**Land off Melksham Road, Great Parks, Holt, BA14 6QP.  
Approval of Reserved Matters (appearance, landscaping, layout and scale)  
pursuant to outline planning permission PL/2022/03315**

**Holt Parish Council has reviewed the revised scheme submitted by the Applicant on 6 September 2024. Holt Parish Council discussed the revised scheme at its meeting on 19 September 2024 and determined to object as follows.**

Chart 10

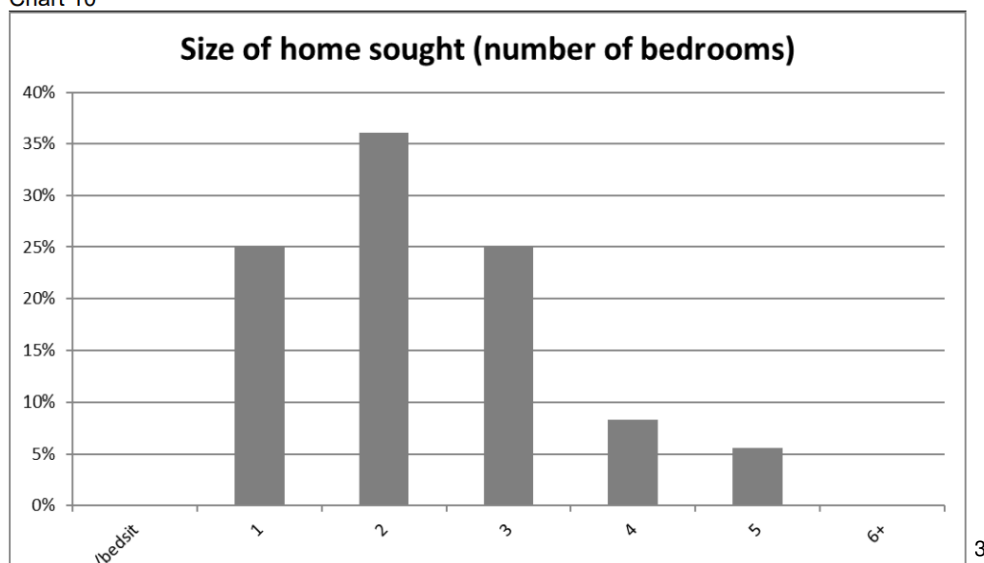
In terms of size, the most popular option was for two bedroom homes and respondents also expressed a need for properties with one, three, four and five bedrooms. No need was declared for studio (bedsit) or homes with six or more bedrooms:

This mix of 2 – 3 beds would be more equitable, with the parking landscape shown in the outline plans and more aligned with the character and appearance of our rural village with driveways and parking not dominating the frontage, contrary to WDG 5.4.4<sup>4</sup>

No more than 22 x 4+ bed properties to reduce the housing density.
